# ATTACHMENT 1

## City of Ryde Submission

### Modification to Ivanhoe Estate Concept Masterplan SSD-8707-Mod-3

**Submission Date:** 31/05/2024  
**Council reference:** COR2024/78/1

**Figure 2:** Extract of the proposed Masterplan

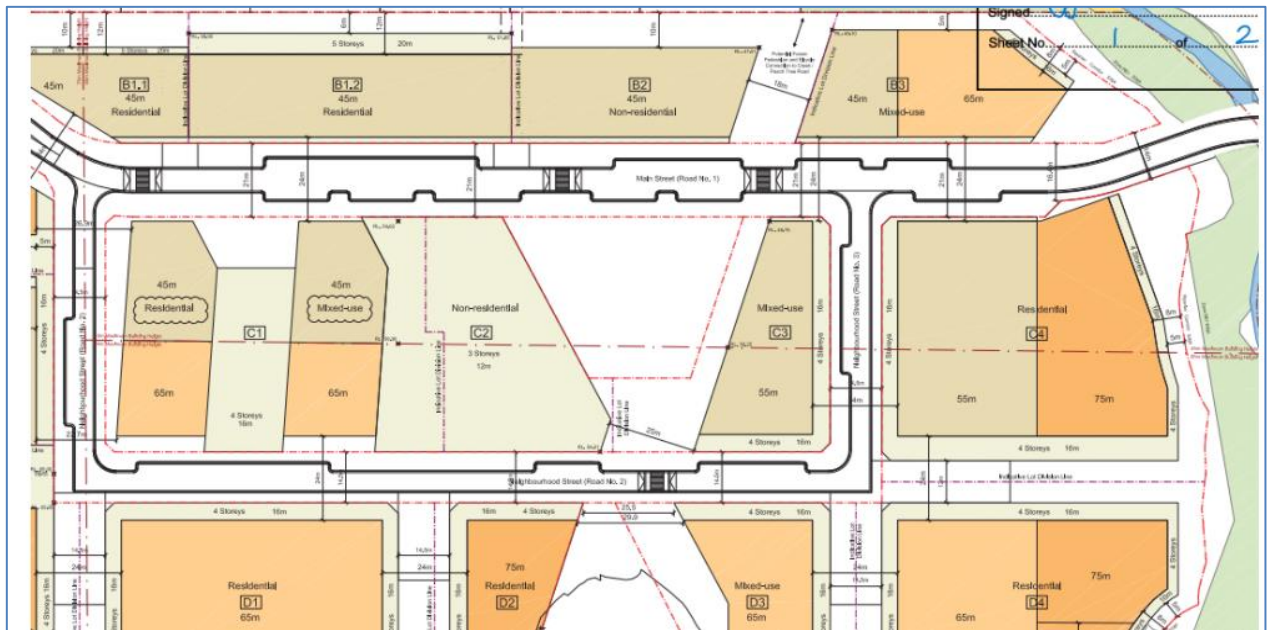
A comparison of the approved Concept with proposed modification is shown below in Figure 1 & 2.

**Figure 3:** Markup of Ground Floor Plan

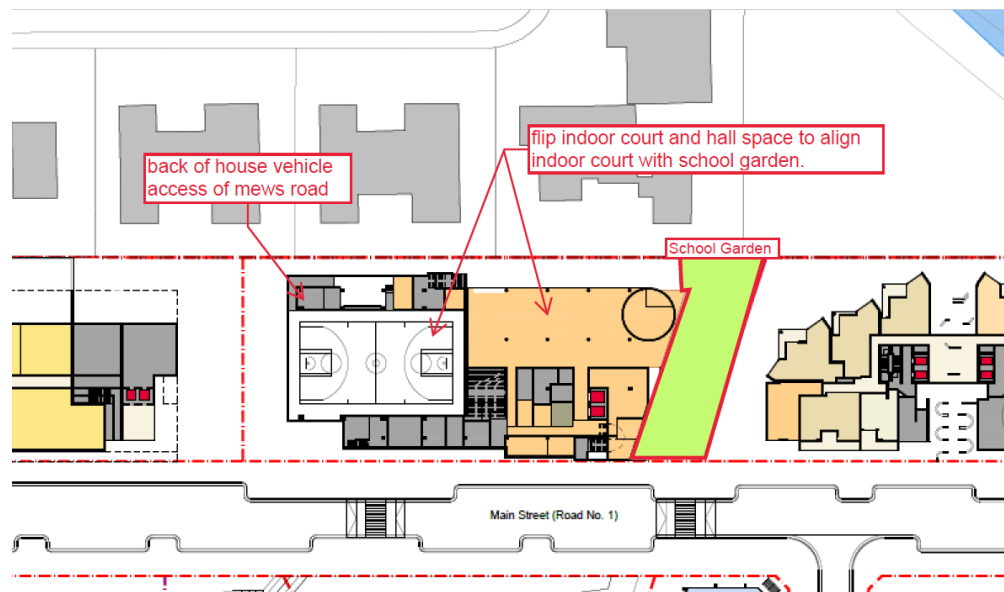
- iv. Council requests that a public access easement is to be created between block B2 and block B3 to allow for pedestrian and cyclists movement between Village Green and Wilga Park, outside of school operating hours.
- v. While it is acknowledged that the detailed layout of the building does not form part of this approval, Council suggests that it is preferable that the indoor court has a direct relationship with the 'School Garden'. This is due to the future community use of the indoor court and the use of the 'School Garden' outside of school hours. Both facilities compliment the activation of the green link to the park. This will also assist in reducing the number of security access points into the school outside of school operating hours. Figure 3 provides a suggested markup of this amendment (Source: Appendix 1 Amended Masterplan Drawings).

**Figure 4:** Markup (yellow) showing suggested location of Back of House Storage (Base Source: Appendix 3)

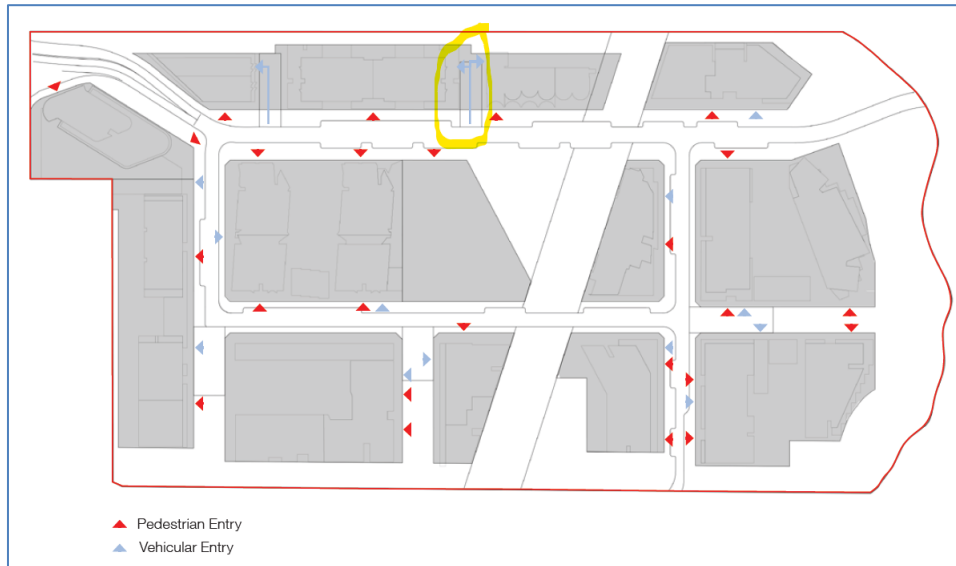
- vi. Council considers the reduction in access from Main Street to Shrimpton's Creek Corridor to 6m to be supportable subject to with the following requirements:
  - Future heavy vehicle access (i.e GPT service truck should be allowed for and demonstrated).
  - Future accessible access through this area is to be provided.
  - Bollards at property boundary on either side to be included in the design of the space and constructed when required.
- vii. Back of house facilities such as loading dock and waste storage should be located on the western side of the school, aligning to the new shared driveway/ road between B1.2 and B2 (refer to Figure 4 below).
